Annex A Response to Departmental Comments

**S.16 Planning Application for Proposed Residential Institution (Student Hostel) in “Residential (Group C)”
with a minor portion within “Green Belt” Zones at Middleton Towers, 140 Pok Fu Lam Road (Rural Building Lot No. 825 RP)
and adjoining Government Land, Pok Fu Lam, Hong Kong**

Responses to Departmental Comments (Resubmission of 4th Batch)

Response to Departmental Comments – Application No. A/H10/98

Traffic Control Management Plan

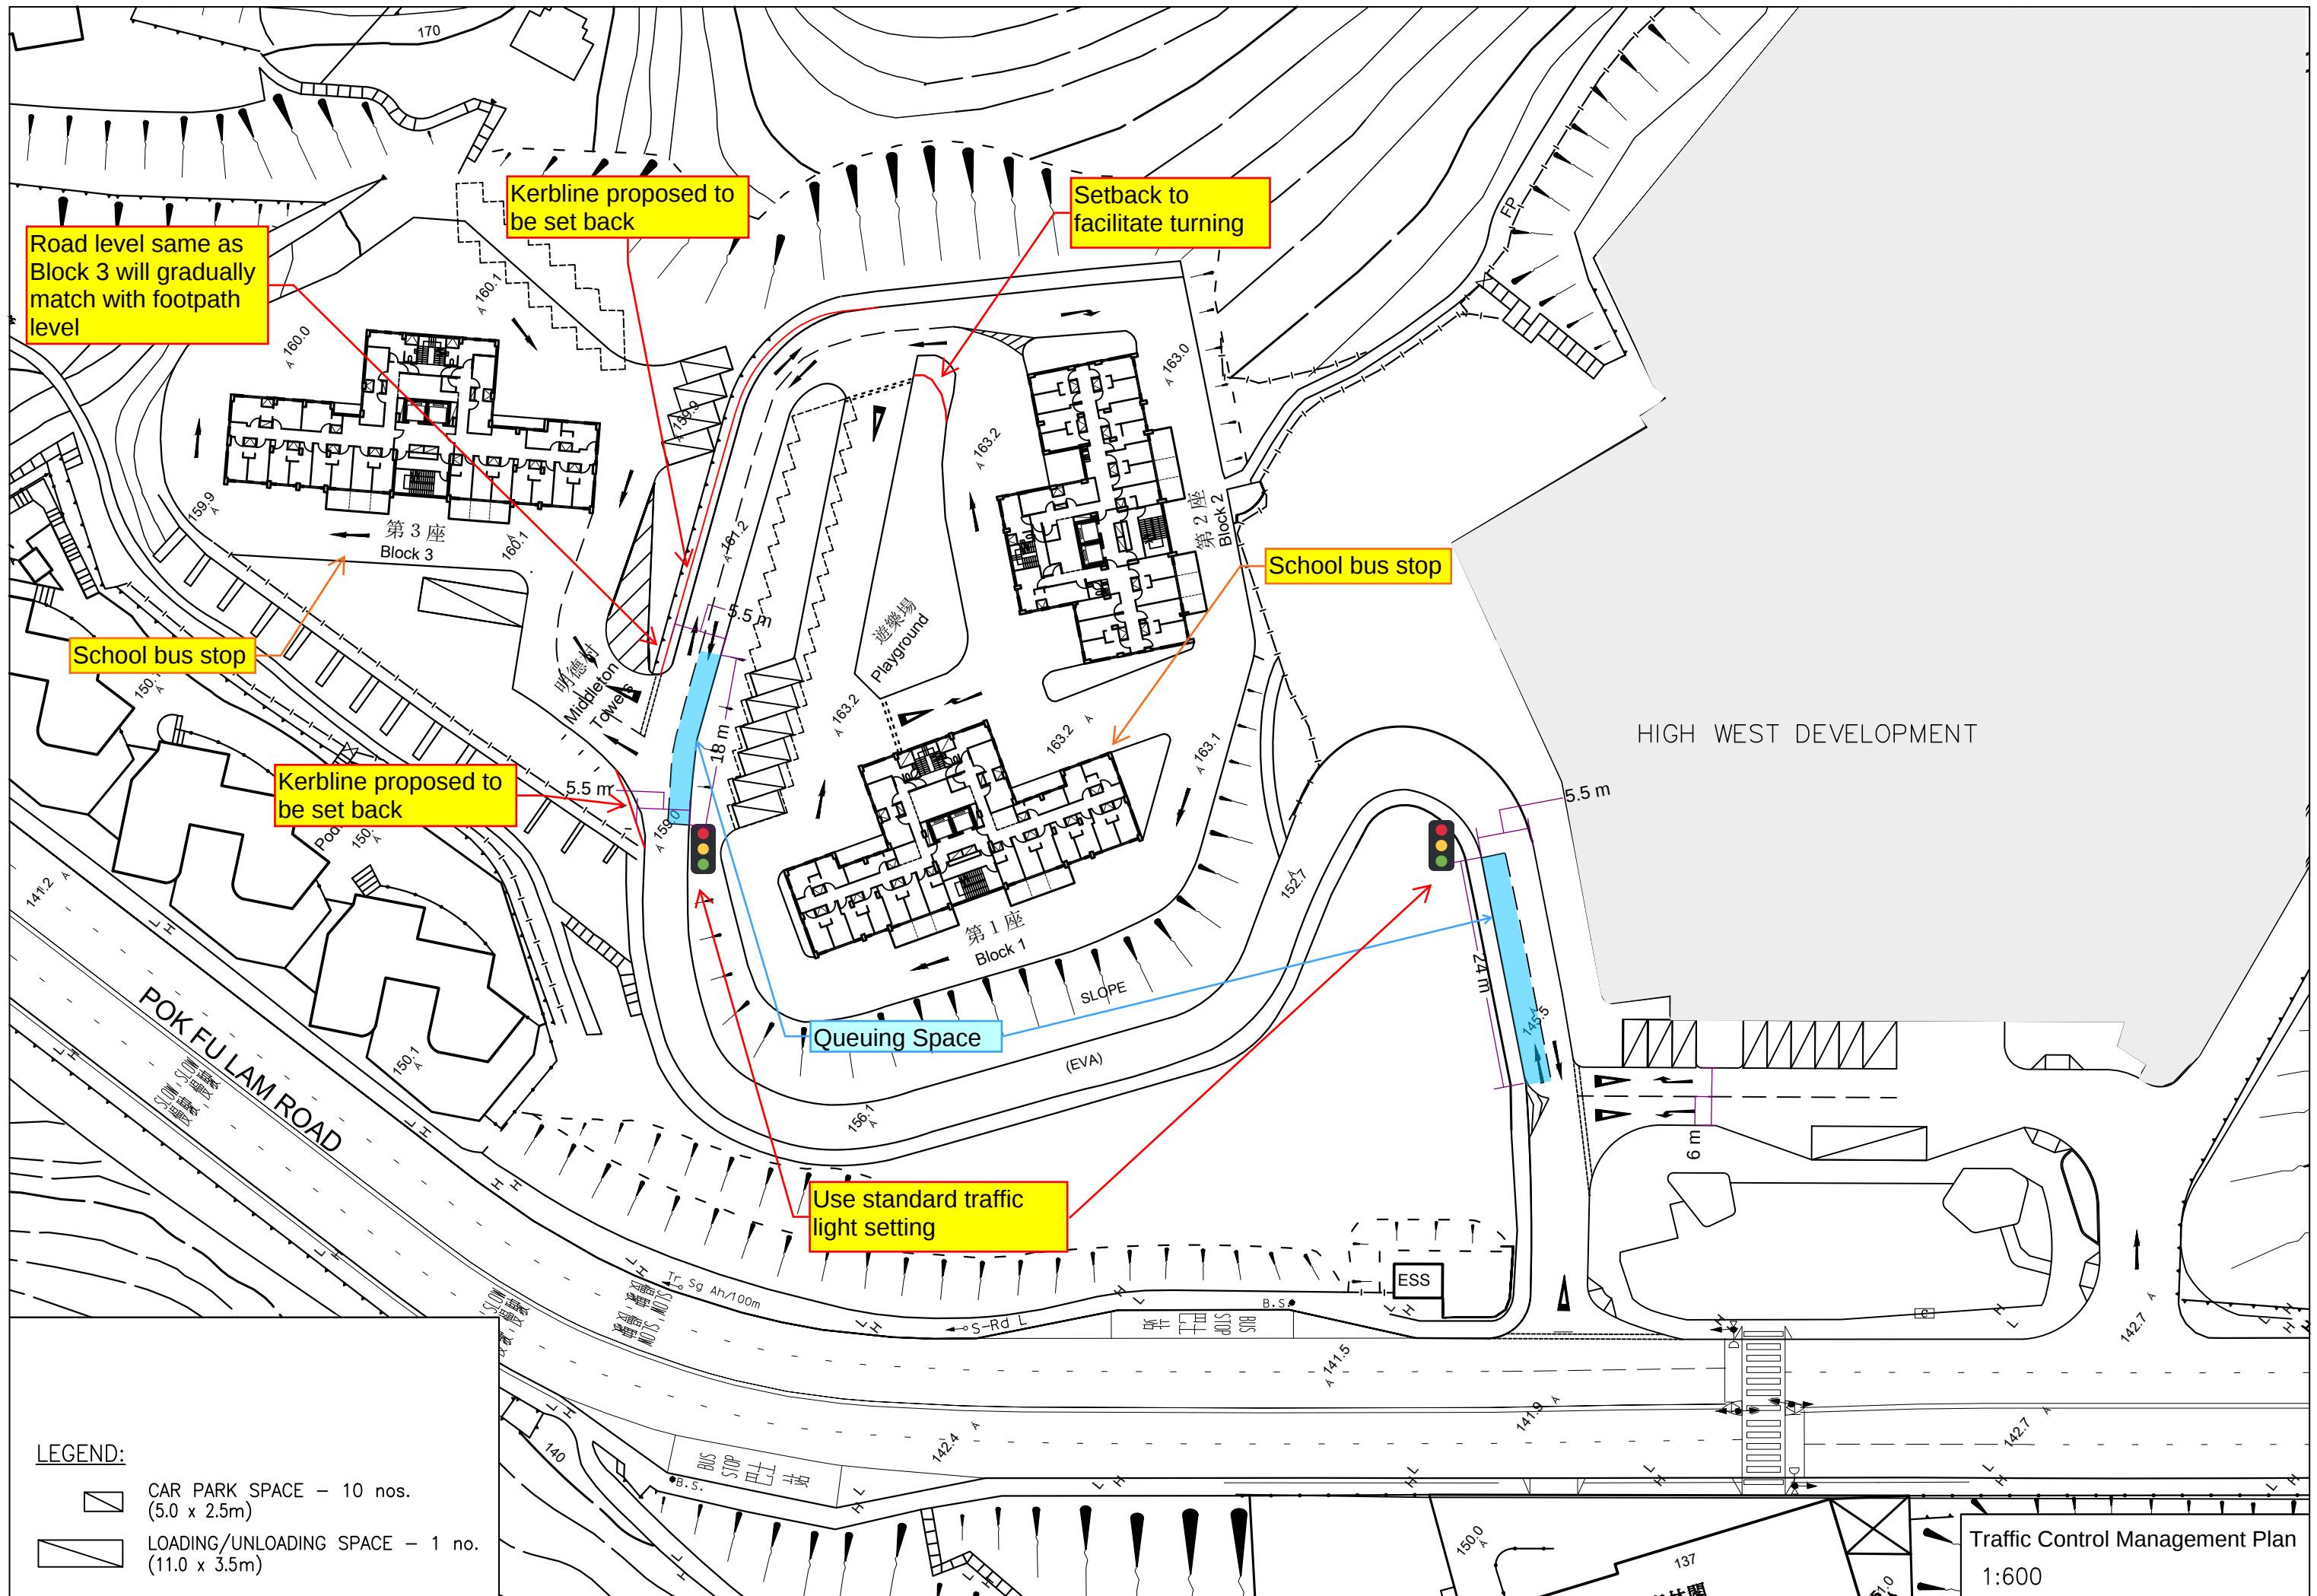
1.3.	(a) Section 3.3.1 and 3.3.2: It is noted that the unnamed single-track access road connecting the subject development is only around 4.5m – 5m and cannot accommodate the two-way movement for private car simultaneously with reference to the swept path analysis. In view of the proposed nature of the student hostel, it is considered additional traffic would use the concerned road section, appropriate traffic improvement measures should be considered to resolve the conflict.	It is noted that the vehicle maneuvering space at localized bending regions on the existing access road is limited and prevents two-way movements. Traffic signals will be implemented to facilitate one-way traffic along the access road and to ensure the internal road safety.
